HISTORIC ALAMEDA HIGH SCHOOL COMMUNITY ENGAGEMENT PROJECT

DRAFT REPORT

PRESENTED MAY 28, 2013

Figure 1: Plan view of the west wing. Column lines have been added to facilitate discussion.

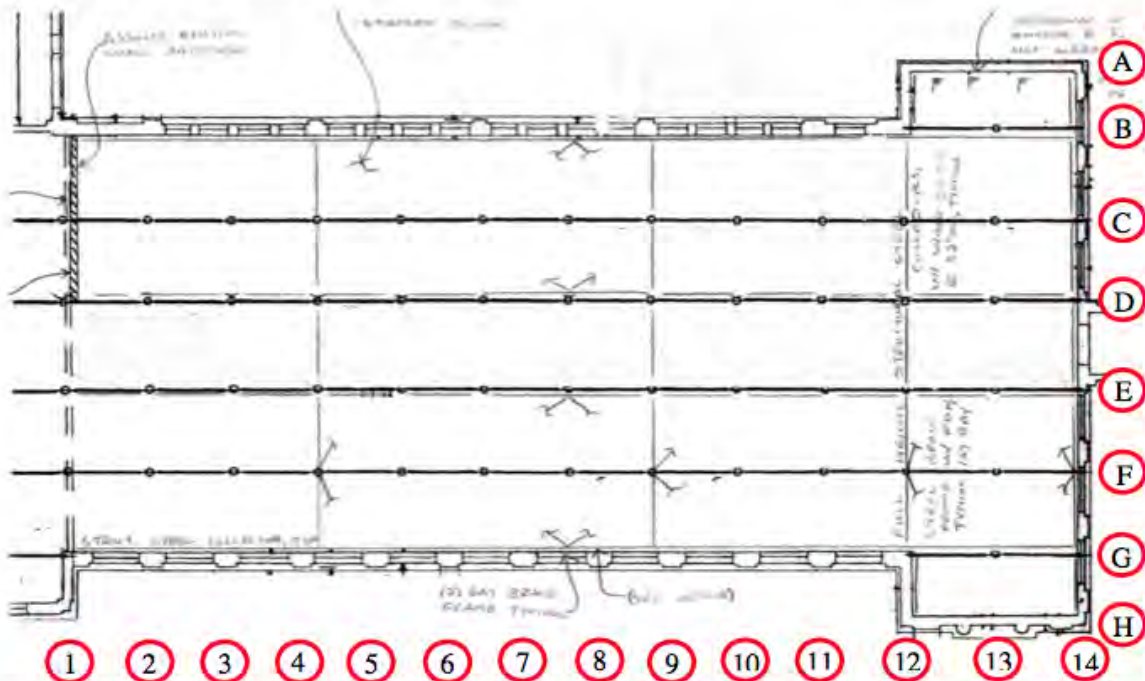
- New parapet bracing at the roof at approximately 8'0" on center.
- New braced frames. ZFA shows braced frames being added on Line B (four bays), Line D (four bays), Line E (four bays), Line G (four bays), Line 4 (four bays), Line 9 (four bays), Line 12 (four bays), and Line 14 (two bays) on all three floors.

- New steel chords and collectors will need to be provided for the new frames. ZFA shows chords and collectors being added on Lines B, D, E, G, 4, 9, 12, and 14 on all three floors.
- New shear transfer details to new collectors through new wood blocking.
- Additional roof-to-wall and floor-to-wall anchors at 32 inches on center, including areas where previously anchored.
- New plywood overlay on roof, upper floor ceiling, second floor, and third floor.
- New foundations for the new braced frames.
- Demolition and reconstruction of the concrete floor framing (second and third floor corridors).
- If the existing mechanical and electrical systems are saved, extensive anchorage and bracing of those systems will be required.
- If the existing non-bearing wall framing is left as is, additional wall anchorage will be required.

- New parapet bracing at the roof at approximately 8'0" on center.
- New braced frames. ZFA shows braced frames being added on Line B (three bays), Line D (three bays), Line E (three bays), Line G (three bays), Line 4 (three bays), Line 9 (three bays), Line 12 (three bays), and Line 14 (two bays) on all three floors.

- New steel chords and collectors. ZFA shows chords and collectors being added on Lines B, D, E, G, 4, 9, 12, and 14 on all three floors.
- New shear transfer details to new collectors through new wood blocking.

- New braced frames. ZFA shows braced frames being added on Line B (two bays), Line D (two bays), Line E (two bays), Line G (two bays), Line 4 (two bays), Line 9 (two bays), Line 12 (two bays), and Line 14 (two bays) on all three floors.
- New steel chords and collectors. ZFA shows chords and collectors being added on Lines B, D, E, G, 4, 9, 12, and 14 on all three floors.
- New shear transfer details to new collectors at approximately half the number of connections as required for Life Safety Level.
- New plywood overlay at the second floor, third floor, and ceiling below roof.
- Anchorage at 32 inches on center for areas not previously anchored.
- New foundations for the new braced frames.

After reviewing ZFA’s recently provided May 16, 2012 partial seismic strengthening plans, the method chosen by ZFA to partially retrofit the structure appears to be unusual in our experience. For example, at most locations, the floor-to-wall connections were strengthened but roof-to-wall connections were not. Since roof-to-wall connections tend to be some of the most vulnerable because of the amplification of seismic forces near the roof due to the effects of higher modes, we would have expected ZFA to improve these connections.

For example, in the longitudinal direction, Lines A and B already have a total of three bays of concrete walls, and Line H already has two bays of concrete walls. While the walls are not detailed per the requirements for new construction in the current building code, we would not anticipate that these walls would fail in-plane to the point of collapse during a 475-year earthquake. Similarly, given the aspect ratio of the building, we do not believe that the building diaphragms are so weak that longitudinal interior lines of resistance need to be added on Lines D and E.

Similarly, in the transverse direction, we are dubious that four lines of resistance need to be added for a collapse prevention scheme. Given that there is already a wall at Line 1, and given that there are two bays

With fewer new braced frames, collectors and shear transfer details would only be required along Lines G, 6, and 13. Two relatively short collectors could be added along Line B if calculations showed that they were required. The number of foundation elements would also be reduced if the total number of braced frames could be reduced from 16 bays to six.

Based on our observations during our most recent site visit, the floor diaphragms are diagonally sheathed with finished wood flooring. Table A1-D of the *International Existing Building Code* gives a strength value of 1,800 pounds per foot for assemblies like this – approximately equivalent to a heavily nailed modern floor diaphragm constructed with plywood. Thus, it is difficult for us to understand ZFA's recommendation to add a plywood overlay on the second and third floors. It once again appears to be an attempt to swap out old for new rather than crediting the existing system with its expected capacity.

We do concur that the existing straight sheathing on the roof is unlikely to be able to resist imposed shear demands, so a plywood overlay on the roof diaphragm would appear prudent for a collapse prevention scheme. However, we suspect that ZFA's proposal to add the plywood to the underside of the ceiling joists is likely more expensive and more difficult than adding it to the top surface of the roof.

Like the discussion of the Collapse Prevention scheme above, we do not believe that the existing floor diaphragms with diagonal sheathing and finished wood floors need plywood overlays, and we doubt very strongly that the concrete slab in the central corridor would need to be demolished and rebuilt, as ZFA alludes to in the second figure in their memo.

Like the Collapse Prevention scheme, we concur that the top level diaphragm needs to have a plywood overlay, although we don't believe that both the roof and the third floor ceiling need to have plywood sheathing added.

We also question why roof-to-wall anchors and floor-to-wall anchors must be added at all locations on all floors, particularly in areas that have already been strengthened. Certainly for a Life Safety or DSA upgrade scheme, anchors should be added in areas where they have not been added already, but ZFA's proposal to add new anchors everywhere at the same spacing everywhere appears to lack finesse. As we have stated, the out-of-plane wall accelerations will be highest at the roof, so it is not clear that third floor anchors would require double the capacity of the roof anchors. Similarly, the anchor forces at the second floor should be markedly reduced, and it seems unlikely that additional anchors would be needed beyond those that were recently added.

Although we were not provided with ZFA's calculations, the designs proposed by ZFA for all proposed levels of intervention appear to be excessive and appear to have assumed that all existing portions of the structural system have no ability to contribute to lateral resistance. Given that ZFA's proposed strengthening measures are so extensive, a zero-intervention option should be presented to AUSD, as should a minimal intervention option. These two schemes would provide AUSD with options in the event that they are unable to raise the money to seismically strengthen the High School as proposed by ZFA. If one of ZFA's concepts is selected for implementation, we recommend that a critical peer review be performed to verify that ZFA is properly crediting the ability of the existing structural elements to contribute to the lateral resistance of the building and that ZFA is designing the minimum work required to achieve the performance goal selected.
